## **COI-1 Structural Engineering Expert Report**

### **MTRCL Shatin to Central Link Contract 1112**

**10 December 2019**

**Figure 1** – Illustration of the coupler connection at the EWL slab side and capping beam / diaphragm wall side

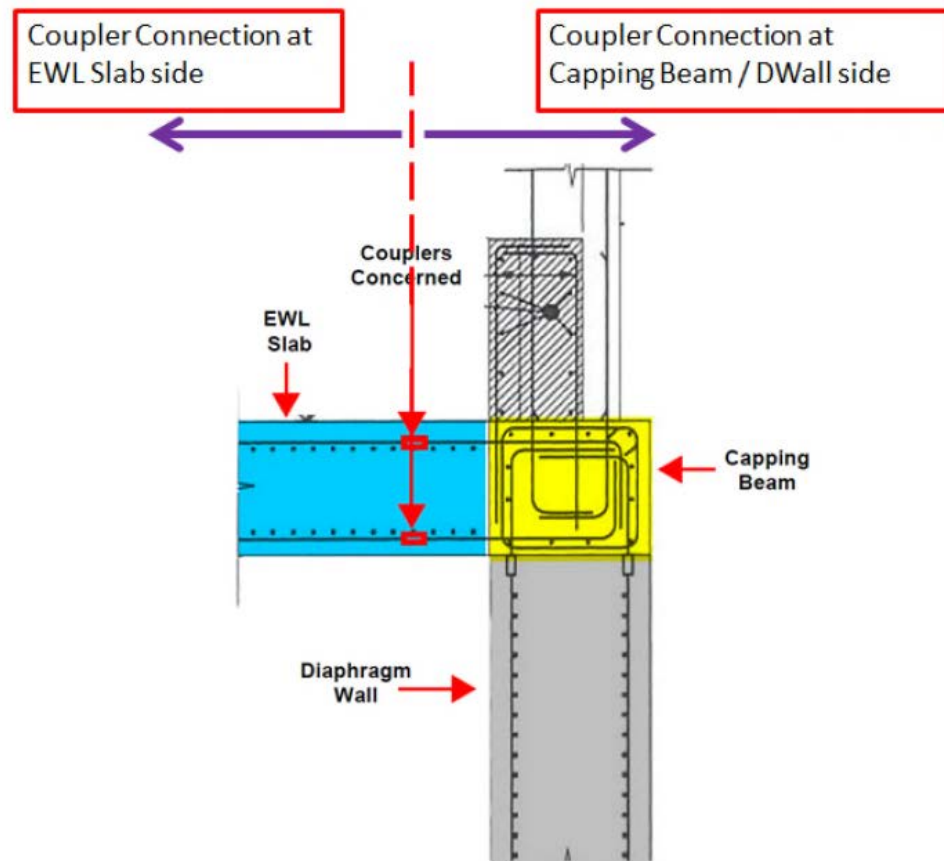
52. The type of defects in relation to coupler connections includes partially engaged coupler assemblies, unconnected couplers and thread cuts.
53. In the EWL and NSL slabs, the defective rates of couplers were estimated to be 36.6% (Table 1, 3.3.24) [OU5/3255] and 33.2% (Table 2, 3.3.24) [OU5/3256] respectively. Detailed results of the tests are set out in Appendix B3 of the Holistic Report. The defective rate of coupler connections in the EWL slab of

Area A was estimated to be 68% [OU5/3728]. As regards the unconnected couplers, as mentioned in slide 11 of the Oral Synopsis of Professor Yin, the 95% (1-sided) confidence interval upper bound of the rate of unconnected coupler in the EWL slab is 15.5% [ER1/12.2]. There was a reason for the adoption of 68% as the defective rate for coupler connections in EWL at Area A. This is the area where the EWL slab was connected to the capping beam on top of the diaphragm wall. The sequence and method of installation of the coupler connections in question were different from the rest of the coupler connections between the platform slabs and diaphragm wall. According to the evidence received during the hearing of the Original Inquiry, the coupler assemblies connecting the platform slabs to the diaphragm wall were originally cast in the diaphragm wall by Intrafor. They were subsequently exposed by Leighton with high pressure water jets. It was then discovered that some of the exposed couplers were disoriented or damaged. These caused a lot of difficulty in the subsequent screwing in of threaded bars and ensuring proper alignment of reinforcement by the steel fixers. Whereas in the case of the coupler connections at the capping beam, the couplers had never been cast in concrete, these coupler assemblies were therefore not damaged and without any issues of misalignment or disorientation. The reinforcement details are shown in the capping beam diagram below (which is reproduced from [OU5/3430]). In such a perfect working condition, one should not have (or would not expect) any difficulty to properly connect the threaded bars to the couplers. It is then obvious that the working methods adopted were different, the working conditions were different, the levels of difficulty involved in the respective installation work were also very different. The corresponding defective rates of the coupler connections installed therefore would unlikely be the same. In the circumstances, it was considered that the defective rate at the area of capping beam should be assessed separately. A 68% defective rate was then worked out based on the number of defective couplers found. I understand and agree with the principle behind this method of assessment.

54. Because of the defective coupler connections, a large amount of design calculations was carried out by MTRCL's consultants, namely Atkins, Arup and AECOM. The consultants carried out an assessment based on the Updated Design of the structure and found that because of reserve capacities, no suitable measures were needed in many areas. The Stage 3 Assessment Report, however, indicated that there were locations on the structure where the strength utilization ratios were greater than unity, meaning that these locations would be overstressed under one or more of the design loading conditions [OU6/4496, 9308]. This was the reason why suitable measures were proposed at these locations. The suitable measures were needed to increase the structural capacity of the structure at these locations so as to lower the utilization ratio down to below 1.

**Figure 3** - Typical section of joint showing the main longitudinal rebar

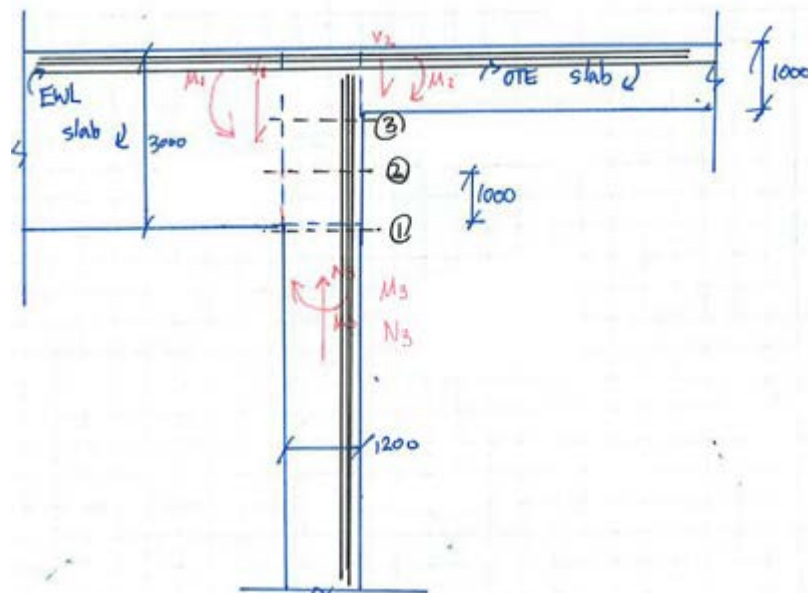
140. To allow the joint to take the large fixed end moment, vertical reinforcements with a L-shape bend at the end (U-bars also help to some extent) were specified by the designer at the joint. The L-shape ends of the bars help to transfer the tensile loads from the vertical rebars of the diaphragm wall to the horizontal rebars in the EWL slab and vice versa. It is now found that both the L-shape bars and U-bars have not been provided at the joint. So, the tension from the vertical rebars in the diaphragm wall can only be transferred to the horizontal rebars in the EWL slabs through the concrete material.

141. It is not desirable to rely on concrete to take tensile force because concrete is weak in tension. The other way was to allow the forces to be transferred by

142. Based on the assumptions of the Original Design, the analyses showed that the joint was overstressed. Under the revised design assumptions of the Updated Design, the results of the simplified hand calculations and finite element analyses by the consultants showed that the joint was no longer overstressed [OU6/4107-4110].
